CITY OF CANNON BEACH

WATER RESILIENCY PHASE 1 – SEISMIC IMPROVEMENTS

ADDENDUM TO ITB - 4

DATE: August 28, 2023

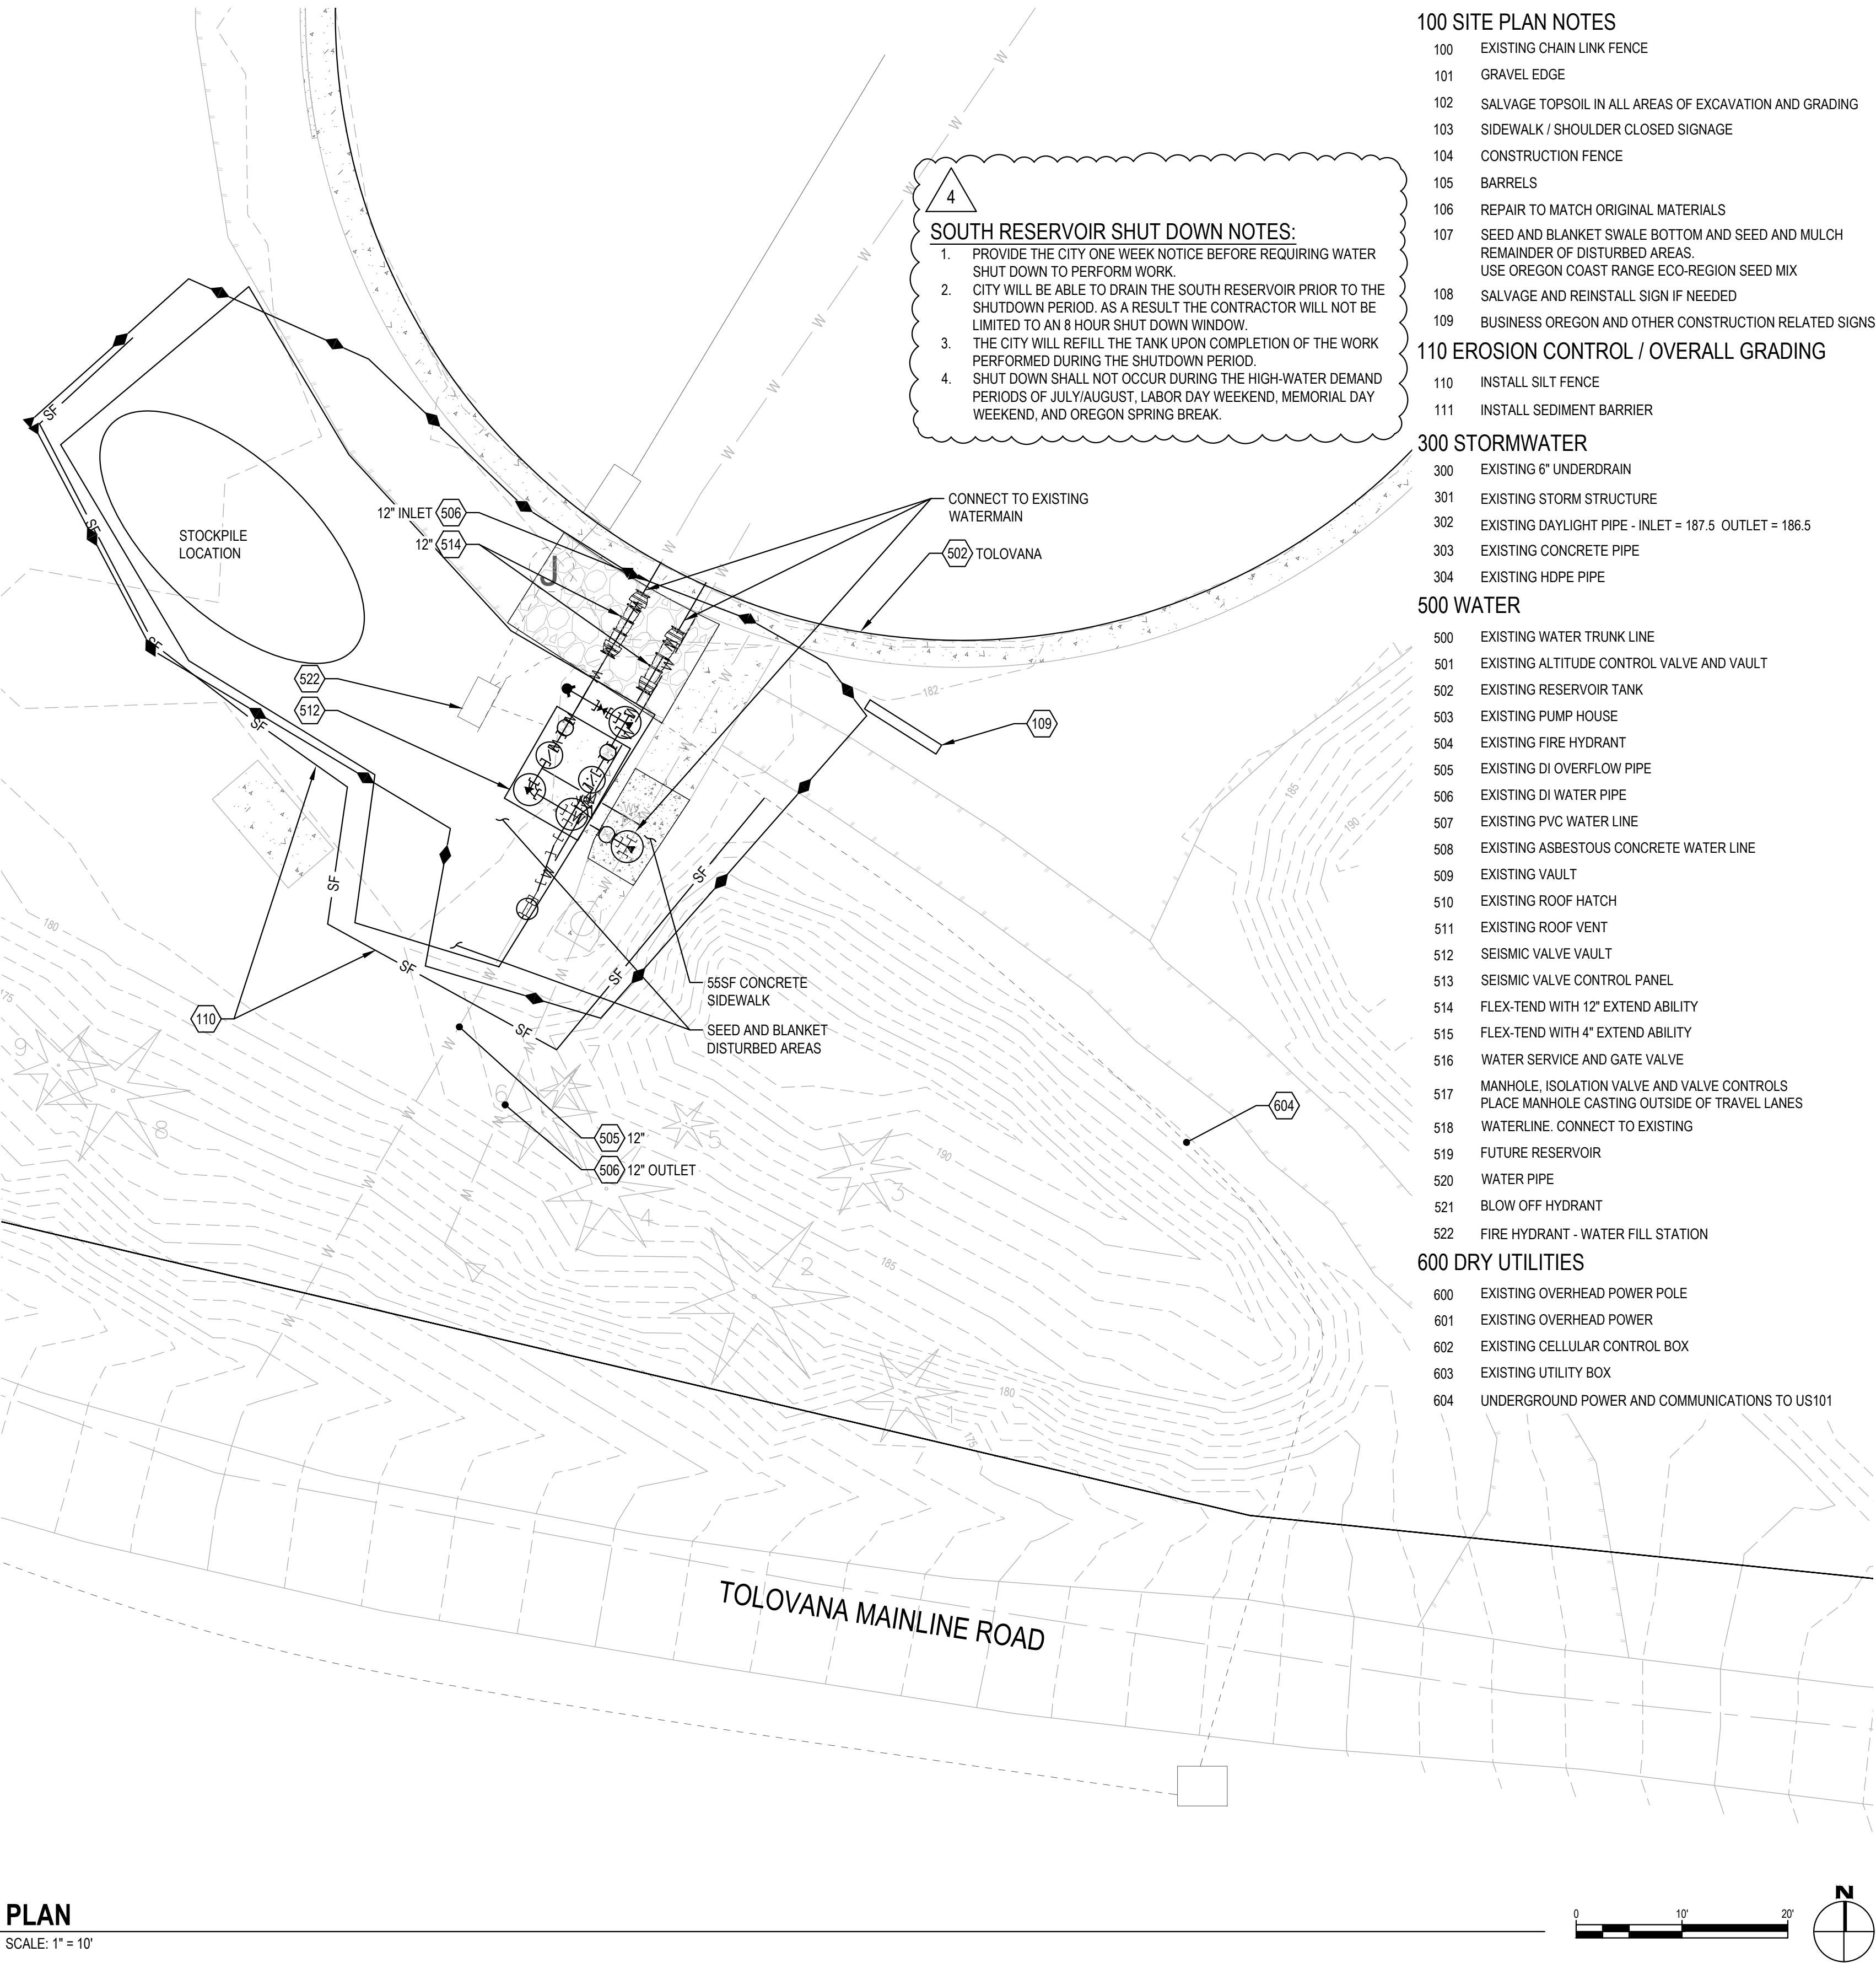
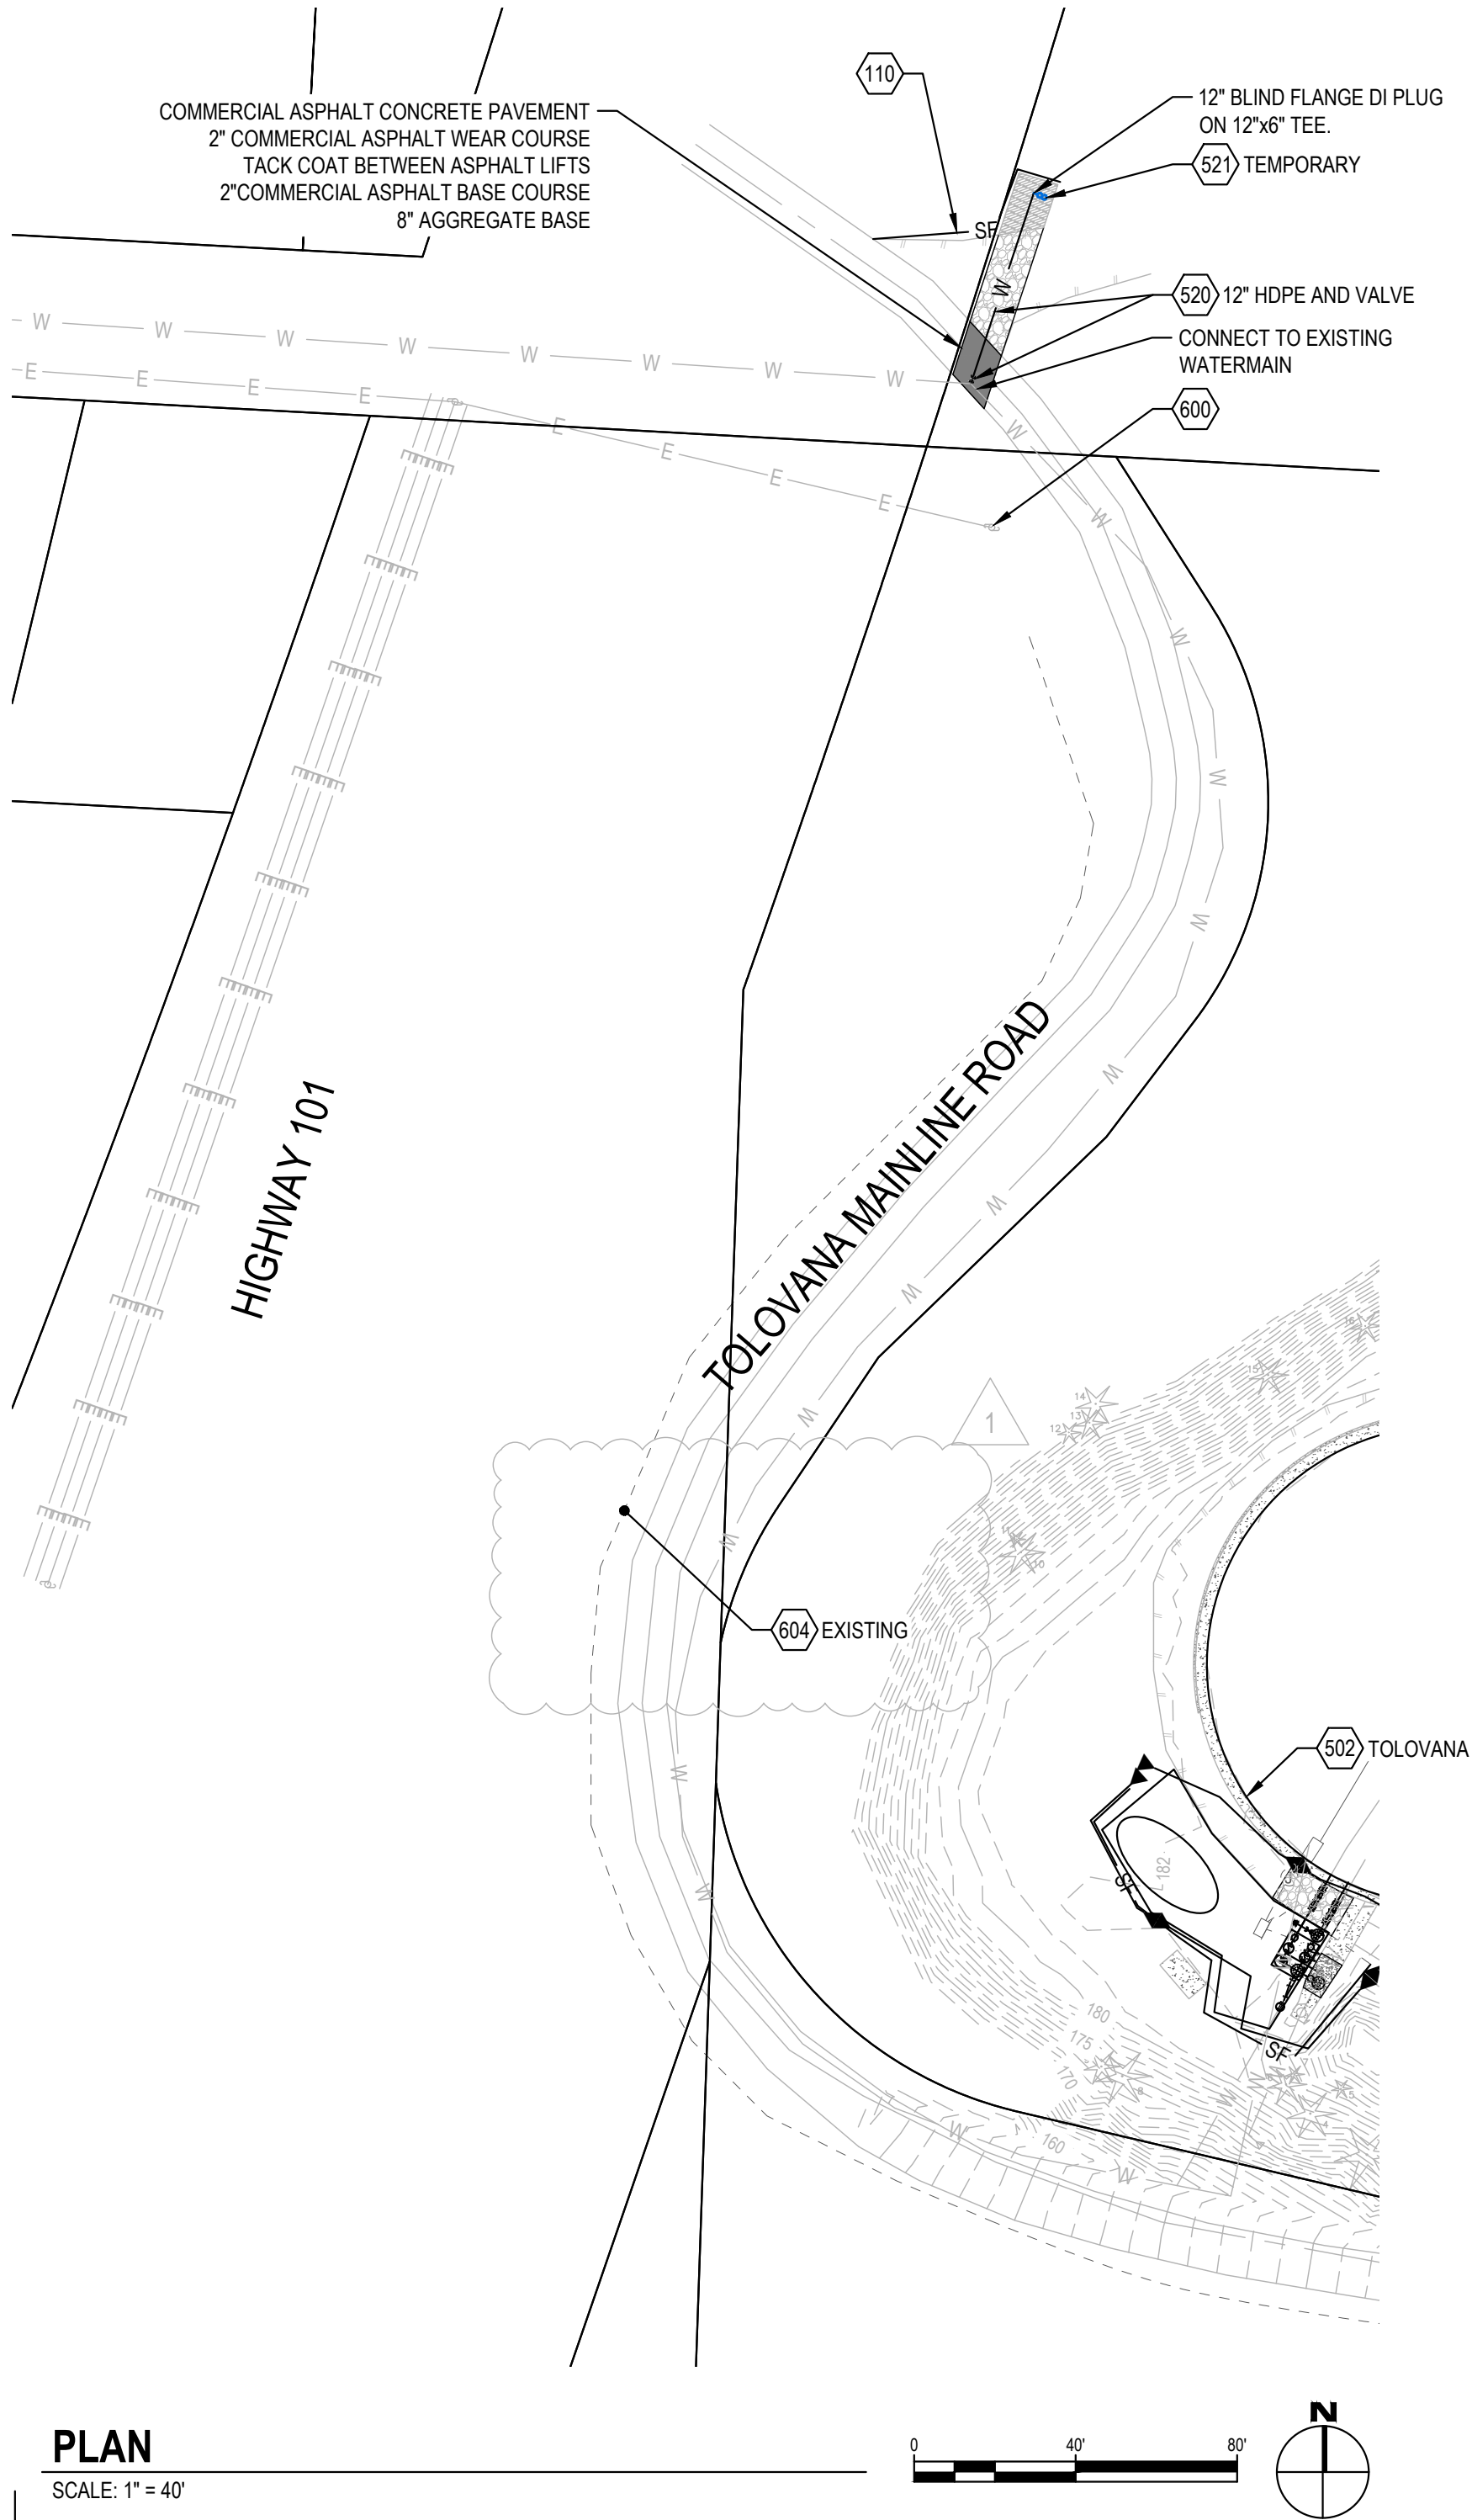
- C104
 - General Notes
 1. City, Contractor, and Engineer to have a meeting to discuss coordination, responsibilities, and limitations related to water shutdowns.

- Added South Reservoir Shut Down Notes:
 1. Provide the city one week notice before requiring water shut down to perform work.
 2. City will be able to drain the south reservoir prior to the shutdown period. As a result the contractor will not be limited to an 8 hour shut down window.

3. The city will refill the tank upon completion of the work performed during the shutdown period.
 4. Shut down shall not occur during the high-water demand periods of july/august, labor day weekend, memorial day weekend, and oregon spring break.

1. PROVIDE THE CITY ONE WEEK NOTICE BEFORE REQUIRING WATER SHUT DOWN TO PERFORM WORK.
2. CITY WILL BE ABLE TO DRAIN THE SOUTH RESERVOIR PRIOR TO THE SHUTDOWN PERIOD. AS A RESULT THE CONTRACTOR WILL NOT BE LIMITED TO AN 8 HOUR SHUT DOWN WINDOW.
3. THE CITY WILL REFILL THE TANK UPON COMPLETION OF THE WORK PERFORMED DURING THE SHUTDOWN PERIOD.
4. SHUT DOWN SHALL NOT OCCUR DURING THE HIGH-WATER DEMAND PERIODS OF JULY/AUGUST, LABOR DAY WEEKEND, MEMORIAL DAY WEEKEND, AND OREGON SPRING BREAK.
